South Texas Project Electric Generating Station P.O. Box 289 Wadsworth, Texas 77483

November 14, 2002
NOC-AE-02001335
10CFR50.90
STI: 31452163

South Texas Project
Units 1 & 2
Docket Nos. 50-498, 50-499
Proposed License Amendment
to Eliminate the Turbine Missile Design Basis

Description of Changes and Safety Evaluation

FIGURE 3.5-1 REVISION 4

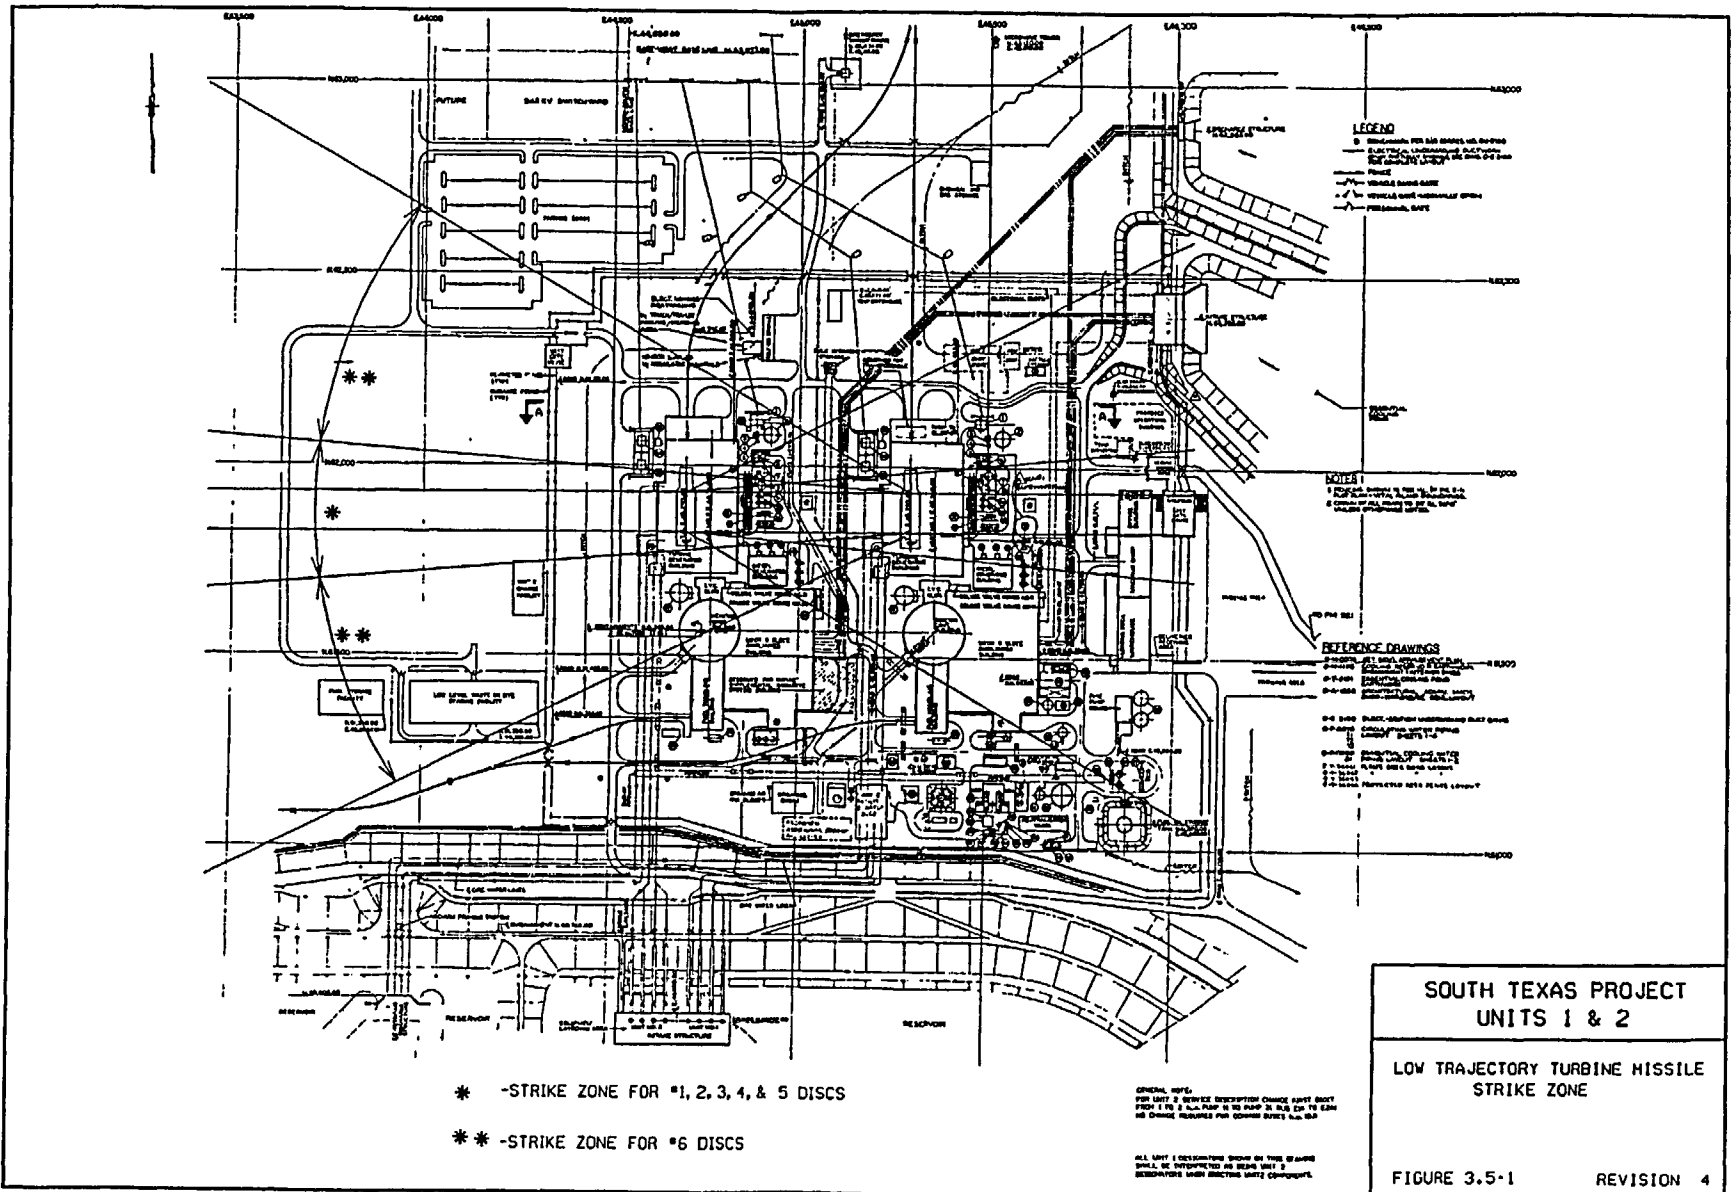
The orientation of the turbine relative to Safety Related Systems, Components, and Structures is shown in STP UFSAR Fig. 3.5-1 (attached). The only safety-related systems, structures or components located within the $\pm 5^\circ$ strike zone are the ECW buried piping and a small portion of the Unit 1 Diesel Generator Building (DGB). The ECW piping is buried to a sufficient depth to prevent damage from a direct strike. The probability of striking the Unit 1 DGB with a missile ejected from the Unit 2 turbine is very small. This very favorable orientation of the STP turbines justifies elimination of the turbine missile generation from the safety analysis. The probabilistic assessment described below shows that the likelihood of core damage, given a turbine missile is generated, is insignificant.

[Note to reviewer: The figures associated with these UFSAR sections will also be deleted.]

The orientation of the turbine relative to Safety Related Systems, Components, and Structures is shown in Fig. 3.5-1. The strike zone of the number 1 through number 5 discs is $\pm 5^\circ$ from the rotational plane. The only safety related systems, structures or components located within the $\pm 5^\circ$ strike zone are the ECW buried piping and a small portion of the Unit 1 Diesel Generator Building. The ECW piping is buried to a sufficient depth to prevent damage from a direct strike. The probability of striking the Unit 1 DGB with a missile ejected from the Unit 2 turbine is very small.

The strike zone of the number 6 discs is $+5^\circ$ to $+25^\circ$ from the rotational plane. Safety related systems, components, and structures are located in the potential strike zone of some of the number 6 discs on Unit 1 and all of the number 6 discs on Unit 2. Because the number 6 discs have the lowest operating stress and lowest operating temperature, these discs have a much lower probability of disc rupture due to stress corrosion cracking and consequential missile generation than most other discs. The 14 number 6 discs currently on site (six operating rotors plus a spare rotor, each with two #6 discs) have individual missile generation probabilities ranging from 6×10^{-7} to 4×10^{-12} (for 60 months operation, probability of failure over entire period).
